# PREDETERMINATION SETTLEMENT AGREEMENT

CP# 08-18-72436  
HUD# 07-18-0016-8

Complainant specifically alleged, in Units 418 and 434, 437 Elgin Lane NW, Linden Oaks Condominiums (“Linden Oaks”), two features in the common areas and two features within two of the covered units appeared inaccessible to a person utilizing a wheelchair for mobility – (1) the route from each unit to the mailbox kiosks requires tenants to travel on their driveways, on public roads, and includes a 2 5/8”-high curb – which violates the prohibition against requiring tenants to travel on vehicular and non-pedestrian routes such as driveways and public roads, and exceeds the 1/4”-maximum change in level; (2) the height of the midlines of the keyholes of the second row from the top of the mail compartments at the mailbox kiosks were measured at 54 3/4”, so the top two rows of mailboxes are higher than the 54”-maximum allowed for a parallel approach by persons using a wheelchair; (3) the change in level from the interior finished floor surface to the top of the threshold at the doorway to the porch in Unit 434 was measured to be 1 7/8”, which exceeds the 1/4”-maximum without a 1:2 beveling that was observed to

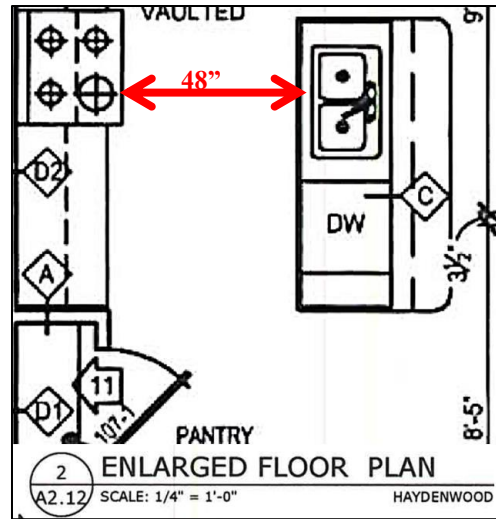
4) The interior threshold heights at the secondary doorway to the porch were measured at all inspected units. The following table below lists the units and interior threshold heights that exceeded the 1/4”-maximum height with no 1:2 beveling.

UNIT #	INTERIOR THRESHOLD HEIGHT
1047 [Birchwood]	1 27/32”
1052 [Capewood]	1 3/4”
434 [Rosewood] – Test Unit <sup>9</sup>	1 23/32”

These thresholds are too high, rendering the doorways unusable by persons using wheelchairs. No information was found in the plans about the designed threshold height at the sliding glass doorways.

After the inspection and before the drafting of the Report of Preliminary Findings, Respondents installed threshold accessible ramps that have running slopes of 7.5%, which are compliant with the 8.33%-maximum running slope for ramps.

- 4) Respondents submitted photographs to ICRC indicating that they have installed accessible ramps at the interior side of thresholds of sliding glass doorways of covered-dwelling units that exceed the ¼”-maximum height to bring them into compliance with the aforementioned requirement; and a copy of the written notice that was sent to current and future tenants about their right to opt out of having the accessible ramps installed at these thresholds, or to have them installed as needed due the onset of a disability.

4) ICRC concurs with Respondents' claim that the photographs they submitted to ICRC indicate they have installed accessible ramps at the interior side of thresholds of sliding glass doorways of covered-dwelling units that previously exceeded the 1/4"-maximum height allowed, and have since brought these thresholds into compliance with the maximum height requirement. ICRC also concurs with Respondents' proposal to notify current and future tenants in writing about the option to opt out of having the accessible ramps installed at the thresholds, or have it reinstalled as requested by the tenant due the tenant's onset of a mobility-impairment health condition. ICRC also concurs that Respondents have provided notices to tenants in accordance with this requirement.
